DUANE ARNOLD ENERGY CENTER

AMENDMENT TO FACILITY OPERATING LICENSE

Amendment No. 115
License No. DPR-49

ATTACHMENT TO LICENSE AMENDMENT NO. 115

FIGURE 3.12-6

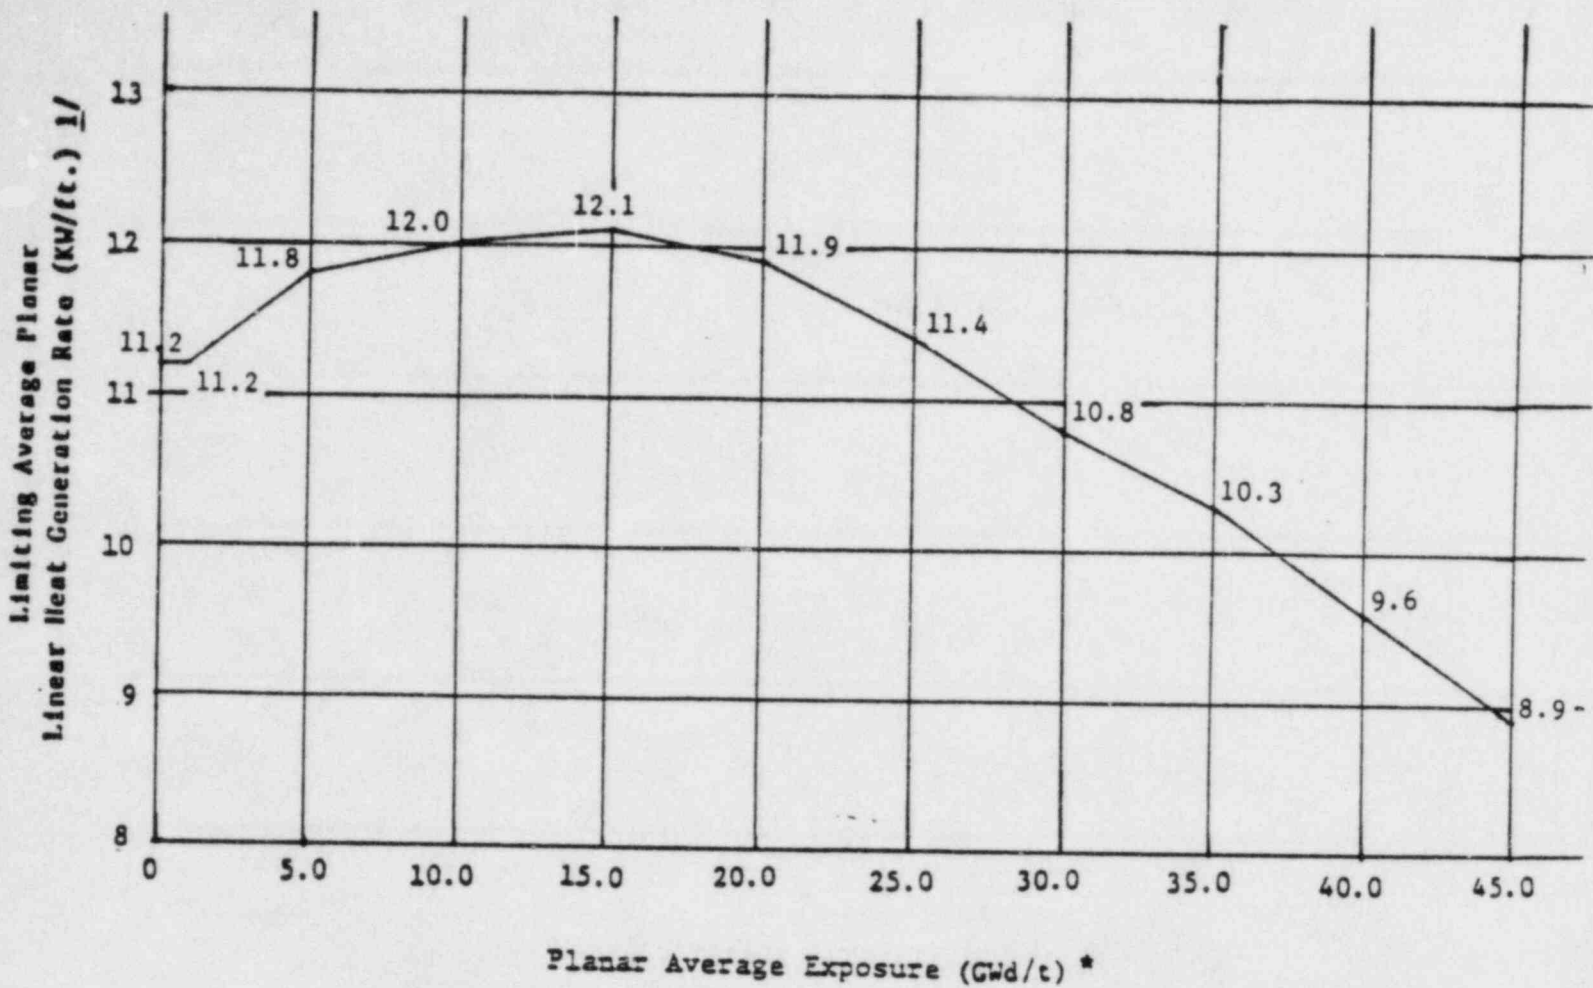
1/ When core flow is equal to or less than 70% of rated, the MAPLEGR shall not exceed 95% of the limiting values shown.

FIGURE 3.12-7

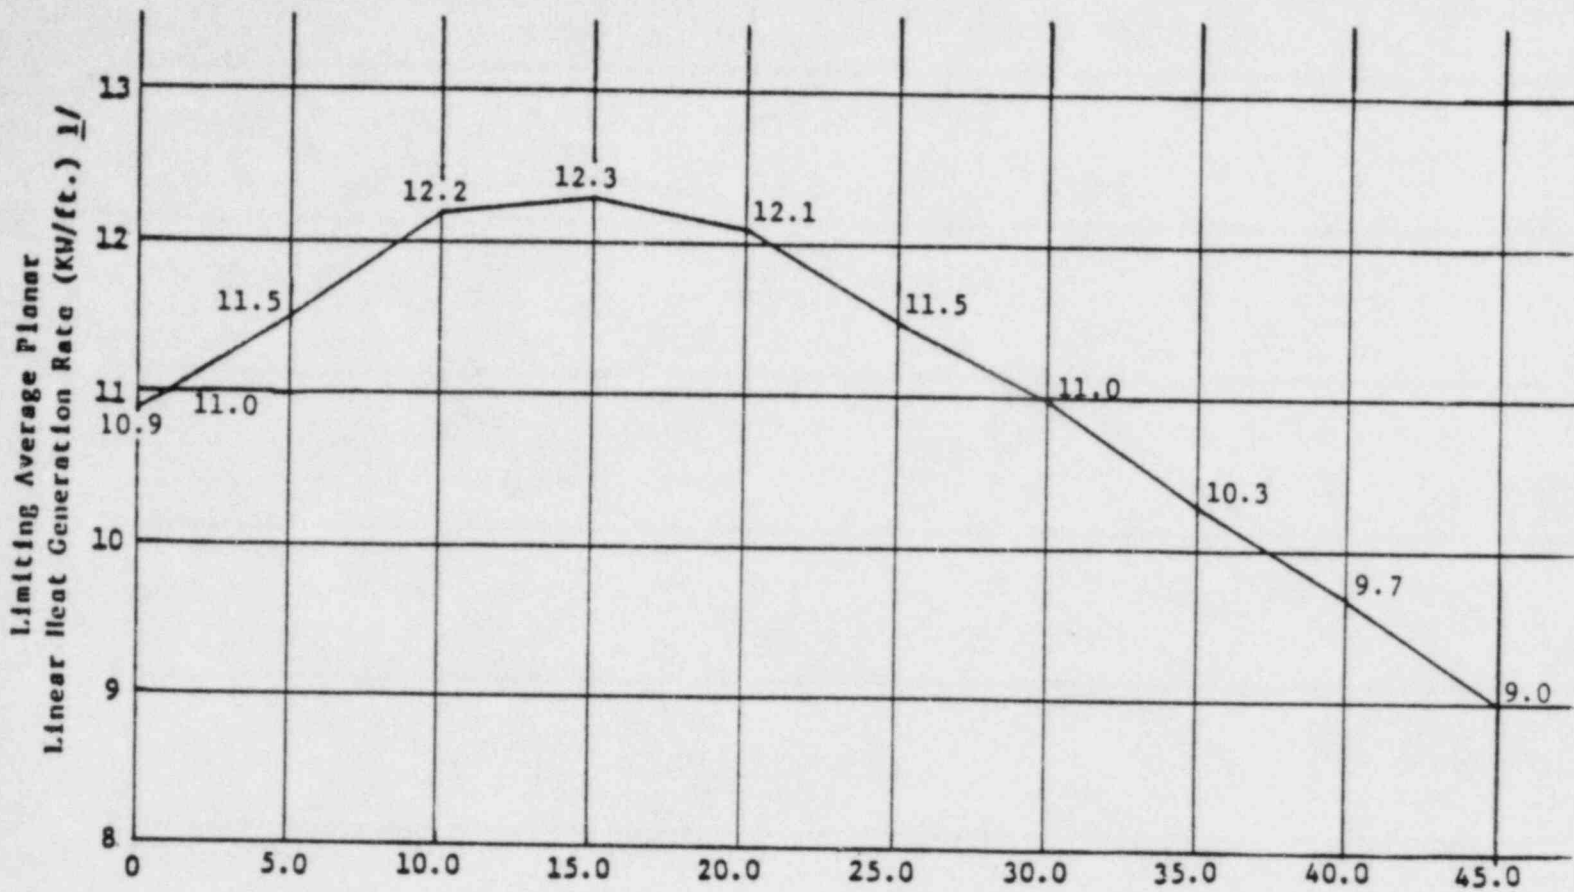
1/ When core flow is equal to or less than 70% of rated, the MAPLEGR shall not exceed 95% of the limiting values shown.
